KAUAI ONE

PRB RESULTS: **AFS SIGNED AND COMPLETE**

PRB RESULTS: **RETURN FOR REWORK**

KAUAI Obstacle Departure Procedure, Lihue Airport, Lihue, HI (PHLI).

# KAUAI ONE DEPARTURE (OBSTACLE) AL-776 (FAA)

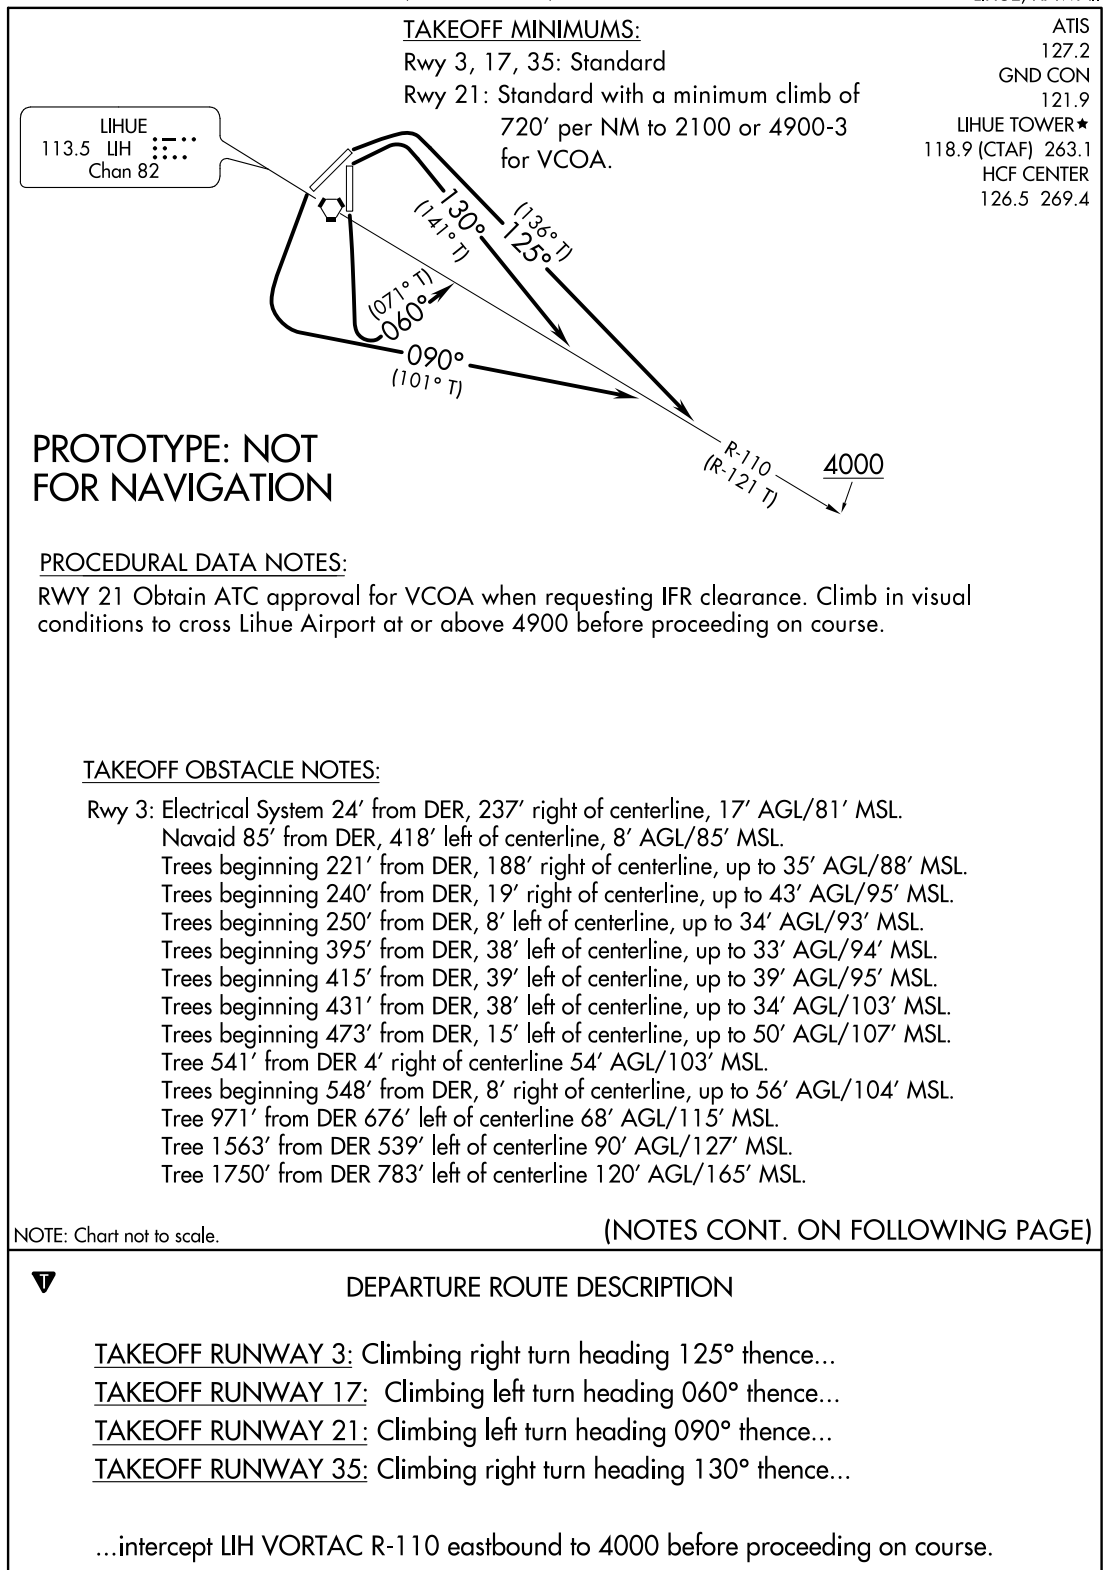
Flight Procedures Cover Page	Task Action: FLIGHT CHECK	Task Type: Graphical DP	Estimated Chart Date: 04/20/2023	APWS Task ID: E4D1B8DCA5674934951CA283E7C24F2D	APWS Project ID: 511671E6F57E47599A5B22AC39CA680C
Procedure: KAUAI ONE DEPARTURE (OBSTACLE)		Enroute: YES	Specialist: Cyrus, Theron		Agreement Number:
Airport ID: PHLI			Airport City: LIHUE		State: HI
Facility ID:	Facility Type:	Flight Inspection Remark Type: New FC Slot			
<div>Procedure Comments:</div> <div>CANCEL NOTAM 0/5015 UPON PUBLICATION.</div> <div>ACTIVE AIRPORT AND RUNWAY DATA USED FOR PHLI.</div> <div>AFS APPROVAL LETTER (1): CLIMB GRADIENT EXCEEDS 500 FEET PER NM.</div> <div>CONTACT CASIMIR TABAKA 405 202 7857.</div> <div>04/21/2023: THIS IS A CORRECTED COPY OF THE FORM APPROVED ON 01/12/2023.</div> <div>MSA: RADIALS /ALTITUDE CHANGED FROM 180-050 3500, 050-180 6500 TO 360--230 3500, 230-360 6400.</div>

**KAUAI ONE  
DEPARTURE  
LIHUE, HI  
LIHUE (PHLI)  
100K - RWY 21  
090 TURN**

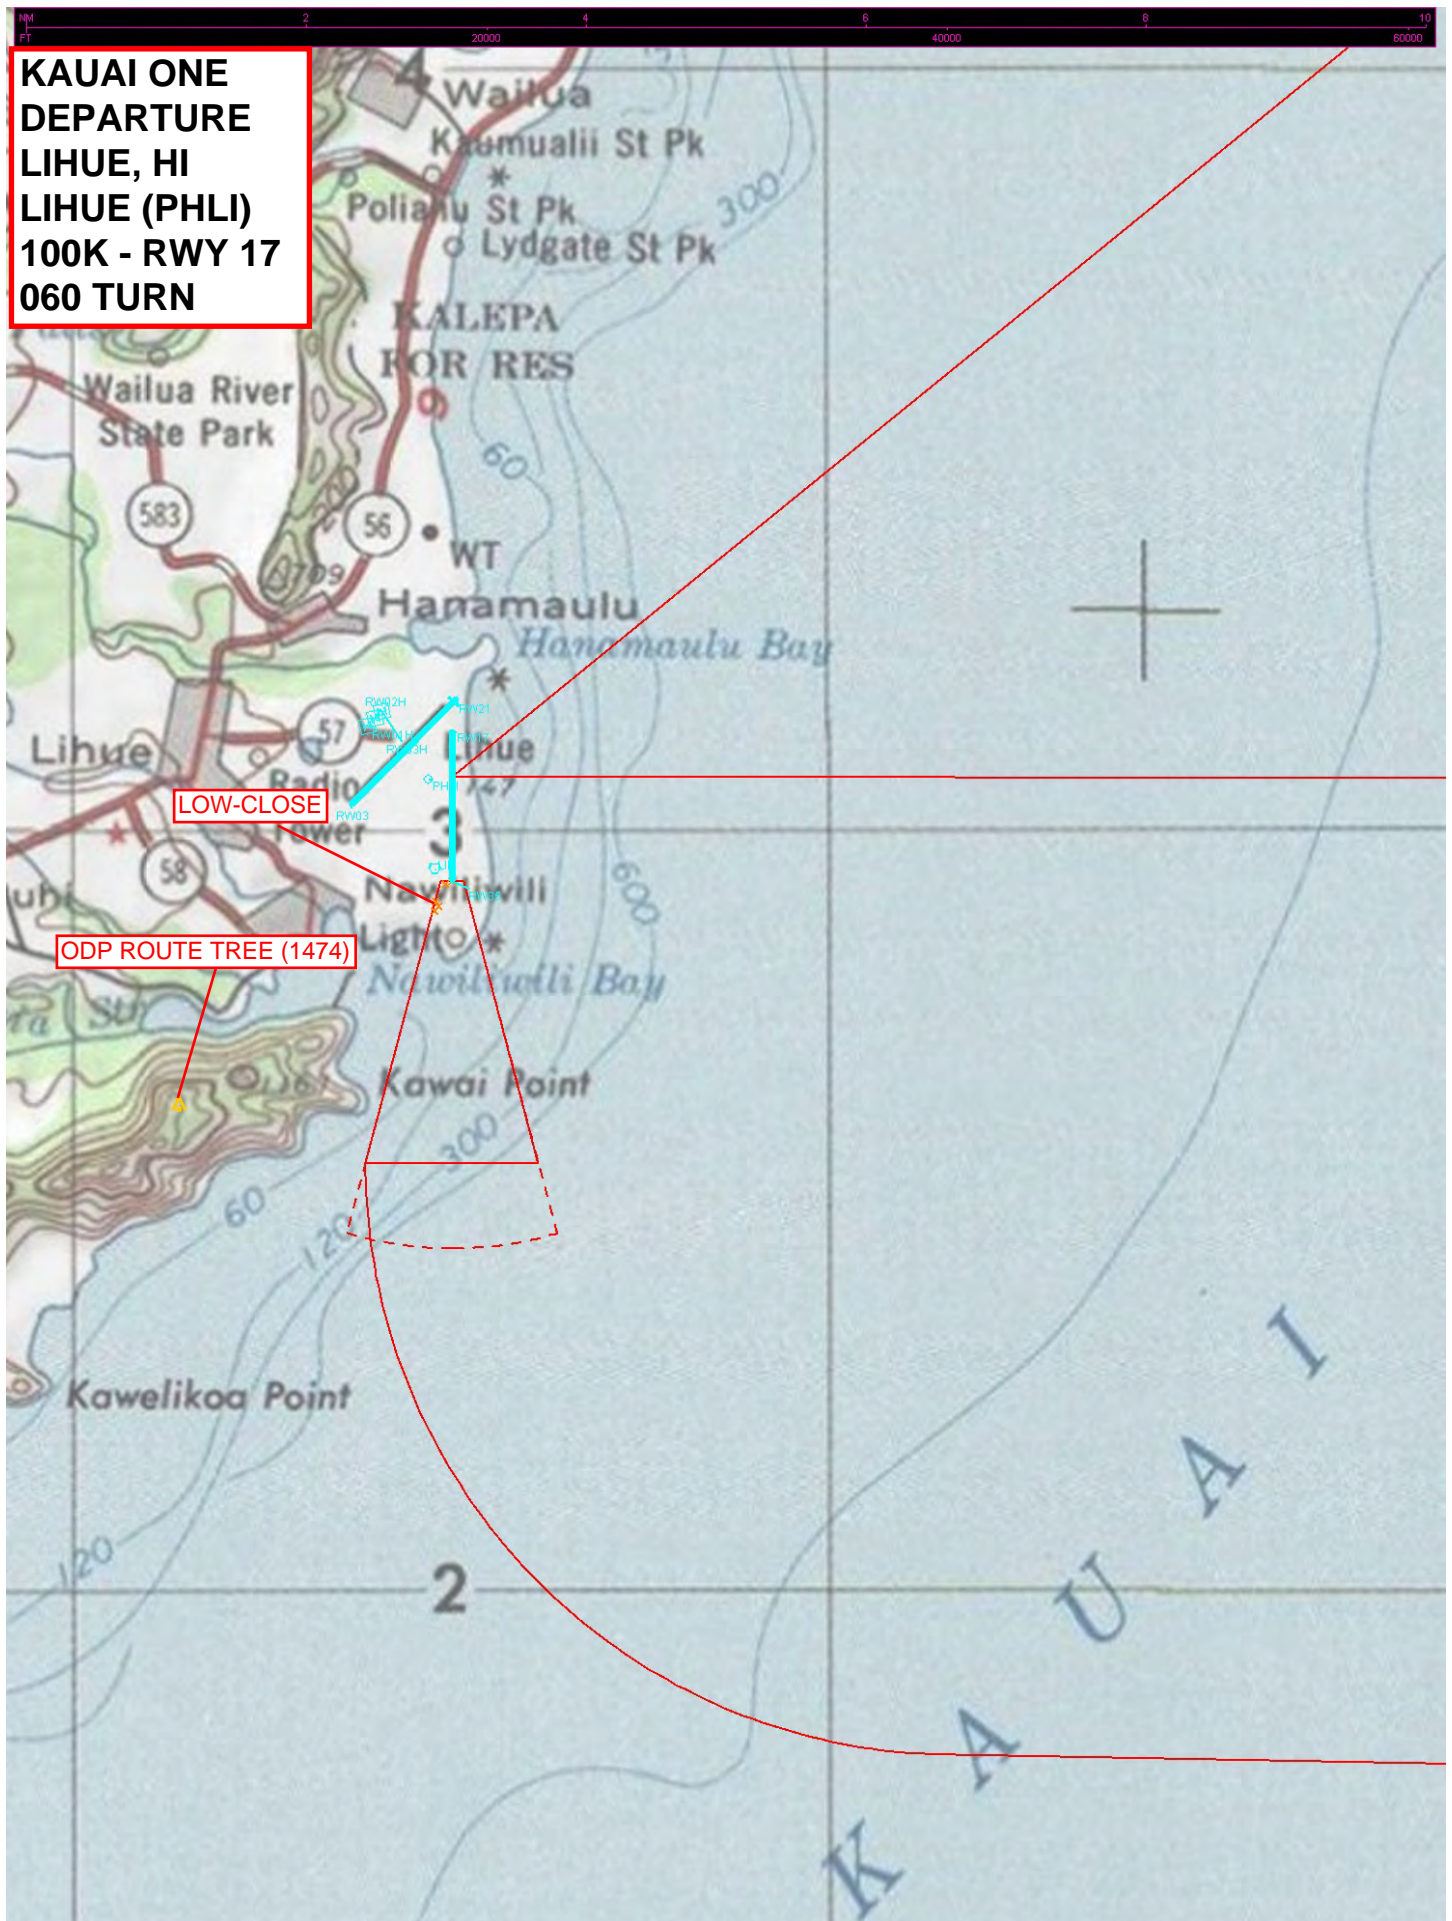
Climb gradient exceeds 500 ft/NM, 8260.46JJ, Para. 2-1-1.d.(2)

The computed climb gradient for RWY 21 is 720 ft/NM to 2100 MSL. The obstacle driving this climb gradient is a 1474 feet MSL tree. The location of this obstacle makes it impossible to design a departure procedure to avoid the possible penetration.

Request approval to publish a minimum climb gradient of 720 ft/NM to 2100 to allow 40:1 obstacle penetrations to be avoided. Any aircraft unable to meet 720 ft/NM climb gradient can conduct VCOA.
